Office Action Summary

10/796,471

ZHANG, LEILEI

DETAILED ACTION

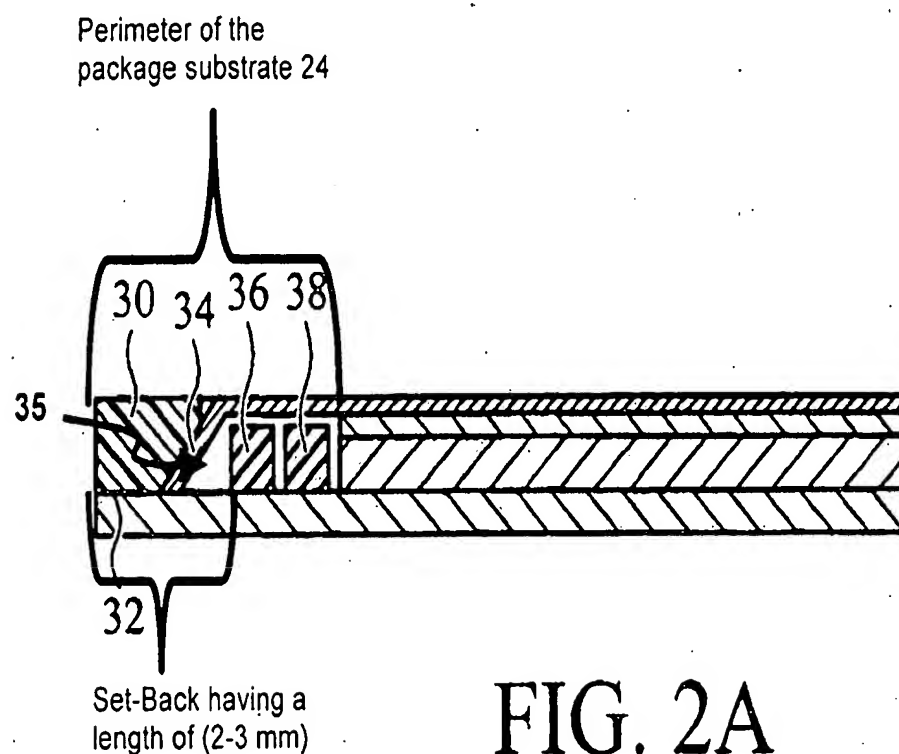
2. The amendment filed February 2, 2007 is objected to under 35 U.S.C. 132(a) because it introduces new matter into the disclosure. 35 U.S.C. 132(a) states that no amendment shall introduce new matter into the disclosure of the invention. The added material which is not supported by the original disclosure is as follows: the original disclosure does not support the subject matter now added to paragraph 0030 since the original disclosure fails to suggest, explicitly or implicitly, that no molding compound is introduced in the space 35, as now proposed by applicant. To the contrary, the original disclosure suggests that molding compound is added in the argued space. For example, paragraph 0030 (of the original specification) discloses that the molding compound is formed on "about 2 mm to about 3 mm of the perimeter of the package substrate 24" [emphasis added]. In addition, paragraph 0030 discloses that "[T]he set-back from the edge of the package substrate 24 to the chip capacitors 36, 38 is typically about 2-3

mm," which is the same length or region disclosed for the molding compound. Please note that this set back region includes the argued space 35 (see fig. 2A, attached below). Thus, the molding compound is also present in the space 35.

In addition, the proposed figures are objected since the cross sectional view as shown in figure 2A does not correspond to the cross section taken along the proposed line A-A in figure 2B. For instance, figure 2A shows a sloped wall (34) completely covered (from top to bottom) with molding compound (30). However, line A-A in figure 2B shows a partially covered sloped wall (34) (see the top portion of the sloped wall that is not covered with molding compound 30). Therefore, the figures remain objected by the examiner.

3. The drawings are objected to because the disclosure fails to describe the "space" or "gap" that is enclosed by package lid 10, substrate 24 and semiconductor IC 26; and that surrounds chips 36 and/or 38 [see figures 2A and 2C]. Corrected drawing sheets in compliance with 37 CFR 1.121(d) are required in reply to the Office action to avoid abandonment of the application. Any amended replacement drawing sheet should include all of the figures appearing on the immediate prior version of the sheet, even if only one figure is being amended. The figure or figure number of an amended drawing should not be labeled as "amended." If a drawing figure is to be canceled, the appropriate figure must be removed from the replacement sheet, and where necessary, the remaining figures must be renumbered and appropriate changes made to the brief description of the several views of the drawings for consistency. Additional replacement sheets may be necessary to show the renumbering of the remaining figures. Each drawing sheet submitted after the filing date of an application must be labeled in the top margin as either "Replacement Sheet" or "New Sheet" pursuant to 37 CFR 1.121(d). If the changes are not accepted by the examiner, the applicant will be notified and informed of any required corrective action in the next Office action. The objection to the drawings will not be held in abeyance.

Applicant is required to cancel the new matter in the reply to this Office Action.

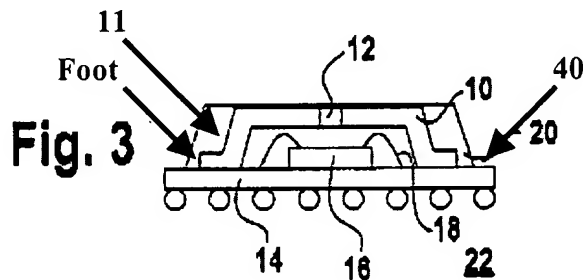
Regarding claims 1 and 31, Fishley et al. teaches a package lid for attaching to a package substrate of a packaged semiconductor comprising a sloped wall (11) configured to provide an exposed perimeter portion (40) of the package substrate (14) [see fig. 3, attached below]. With regards to the limitation that the sloped wall is used or configured to provide an exposed perimeter portion when the package lid is disposed on the package substrate, the court has held that a recitation of the intended use of the claimed invention must result in a structural difference between the claimed invention and the prior art in order to patentably distinguish the claimed invention from the prior art. See *In re Pearson* 181 USPQ 641 (CCPA 1974) and *In re Swinehart* 169 USPQ 226 (CCPA 1971). In the instance case, Fishley et al. teaches a sloped wall (11) configured to provide an exposed perimeter portion (40) of the package substrate (14) when the package lid (10) is disposed on the package substrate (14) to allow application of a molding compound (20) on the exposed perimeter portion (40) of the package substrate (14), the molding compound (20) contacting the sloped wall (11) to secure the package lid (10) to the package substrate (14) of the packaged semiconductor (22) [see fig. 3,

attached below]. Thus, Fishley et al. anticipates the claimed invention since the prior art structure is capable of performing the claimed intended use.

Regarding claim 3, Fishley et al. teaches a foot ("foot") around at least a portion of the perimeter of the sloped wall (11), configured to contact the package substrate (14) when the package lid (10) is placed on the package substrate (14) [see figs. 1 and 3].

Regarding claim 10, Fishley et al. further teaches a vent (12) provided on the top side of the package lid (10) [see fig. 3].

Regarding claim 19, Fishley et al. further teaches that the package lid (10) is disposed on the package substrate (14) to provide the exposed perimeter portion and further comprising: first molding compound (M1) applied to a first portion of the exposed perimeter portion (portion of substrate 14 covered with first molding compound M1) and contacting the sloped sidewall (11) [see fig. 3, below], and second molding compound (M2) applied to a second portion of the exposed perimeter portion (portion of substrate 14 covered with first molding compound M2) and contacting the sloped sidewall (11); wherein the first portion of the exposed perimeter portion is opposite the second portion of the exposed perimeter portion [see fig. 3, below].

Regarding claim 21, Fishley et al. teaches the package substrate includes a solder ball-grid array (S1) for connecting the packaged semiconductor to a printed circuit assembly [see fig. 3, above].

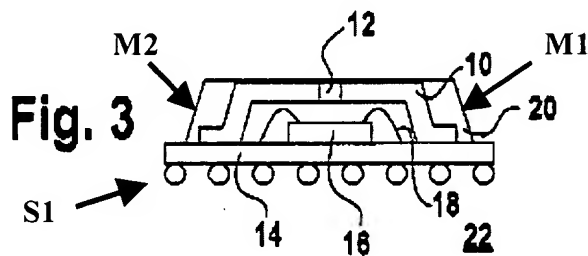
Regarding claim 1, Tang et al. teaches a package lid for attaching to a package substrate of a packaged semiconductor comprising a sloped wall (321) [see figures 1 and 2] With regards to the limitation that the sloped wall is used or configured to provide an exposed perimeter portion when the package lid is disposed on the package substrate, the court has held that a recitation of the intended use of the claimed invention must result in a structural difference between the claimed invention and the prior art in order to patentably distinguish the claimed invention from the prior art. See *In re Pearson* 181 USPQ 641 (CCPA 1974) and *In re Swinehart* 169 USPQ 226 (CCPA 1971). In the instance case, Tang et al. teaches a sloped wall (321) configured to provide an exposed perimeter portion (area not covered with molding 33) of the package substrate (30) [see figs. 1 and 2]. Thus, Tang et al. anticipates the claimed invention since the prior art structure is capable of performing the claimed intended use.

Regarding claim 12, Tang et al. teaches a vertical wall (V1) around a top (322) of the package lid (32) [see fig. 2, attached above].

Regarding claim 13, Tang et al. teaches fiducial marks (consider protrusion P1 or 325) formed in the rim (V1) [see fig. 2, attached above].

Regarding claim 19, Tang et al. teaches a first molding compound (consider the molding compound 33 formed on the sloped wall (321) located on the left side of the structure as shown in figure 2). and a second molding compound (consider the molding compound 33 formed on the sloped wall (321) located on the right side of the structure as shown in figure 2).

Regarding claim 11, Fishley et al. fails to teach a gap in the sloped wall. However, Tang et al. teaches the claimed limitation in figure 2. For instance, Figure 2 shows a gap (321a) in the sloped wall (321) of the package lid (32).
